Staff Report Z-90-17-4 January 12, 2018

Request From: C-2 TOD-1 (4.97 acres)

Request To: WU Code (Walkable Urban Code)

Location: Southeast corner of 19th Avenue and

Source: Solano TOD District Policy Plan, City of Phoenix Planning and Development Department

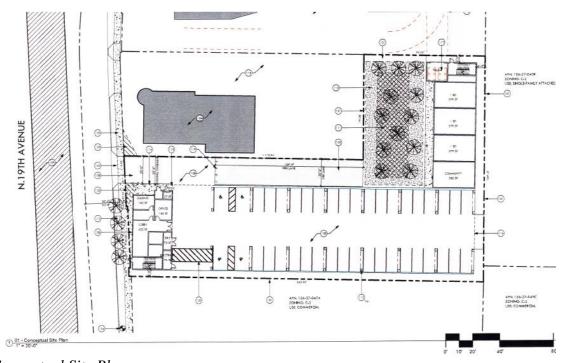
6. The Solano TOD Policy
Plan utilized the Medium
Urban Center place type to
determine the
recommended scale and
character of the area
around the 19th Avenue
and Camelback Road light
rail station, and this scale
and character was
illustrated in both the
conceptual master plan and
the conceptual zoning plan.
The subject site has a

suggested zoning designation of T5:5 with a maximum building height of 56 feet. The request is consistent with the conceptual master plan transect of T5:5.

Conceptual Site Plan Source: Architectural Resource Team

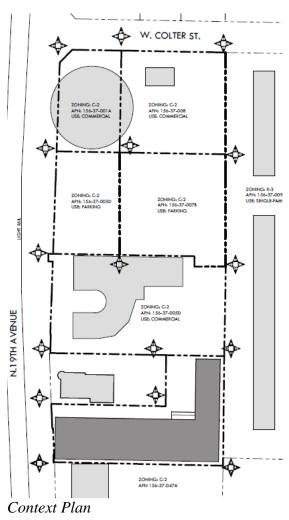
8. The conceptual site plan proposes a four story wood framed multifamily residence over concrete podium on approximately 0.77-acres of the larger 4.97-acre subject site. Ground level of the proposed multifamily will include parking, three ground level units and a community room near the northeast portion of the site, a large common open space area, as well as a lobby, office space, and bicycle storage programmed along 19th Avenue. The elevations show a storefront frontage type along the 19th Avenue frontage. Upper levels include additional support spaces such as laundry rooms and community rooms along with a mixture of one, two, and three bedroom units accessed by a double-loaded interior corridor. Existing buildings are to remain for the larger 4.97-acre subject site with future development still to be determined. Staff is recommending a stipulation that all future phases of development shall be reviewed and approved through a public hearing process prior to preliminary site plan approval. This is addressed in Stipulation 1.

environment where trees can be placed without conflict with utilities, staff is recommending all future phases of development along 19th Avenue shall have buildings setback a minimum distance of 12 feet to allow trees to be placed between the buildings and sidewalk along the 19th Avenue frontage. This is also addressed in Stipulation 1.

Multiple utility conflicts have been identified running parallel with the proposed sidewalk along the 19th Avenue frontage reducing the ability to plant shade trees in the required minimum five-foot-wide landscape strip between the sidewalk and back of curb. These utility conflicts will require the applicant to consider structural shade elements, trellises, or covered walkways attached to the primary building in order to meet the minimum building and shade requirements of the WU Code Section 1304.F. for this first phase of development. Projections in the right-of-way are permitted with a minimum 16-foot height clearance within six feet of public water/sewer lines, unless shade is retractable or an encroachment permit is secured as administered by the City of Phoenix. Additional Frontage Standards can be found in the WU Code Section 1305. The applicant is encouraged to continue working with staff to update their proposal as it proceeds through the site development review process. This is addressed in Stipulation 2.

- 1. Conceptual site plan and elevations, for all future phases of development after the proposed 72-unit Multifamily development, shall be reviewed and approved by the Planning Hearing Officer through the public hearing process for stipulation modification prior to preliminary site plan approval with specific regard to the inclusion of the below elements. This is a legislative review for conceptual purposes only. Specific development standards and requirements will be determined by the Planning Hearing Officer and the Planning and Development Department.
 - A. A minimum landscape setback of 12 feet shall be required along the

west property line to allow trees to be placed between the buildings and sidewalk along the 19th Avenue frontage, as approved by the Planning and Development Department.

- 2. The developer shall work with the Planning and Development Department to determine a frontage type appropriate for the 19th Avenue street frontage which will also provide the shade required by the Walkable Urban Code.
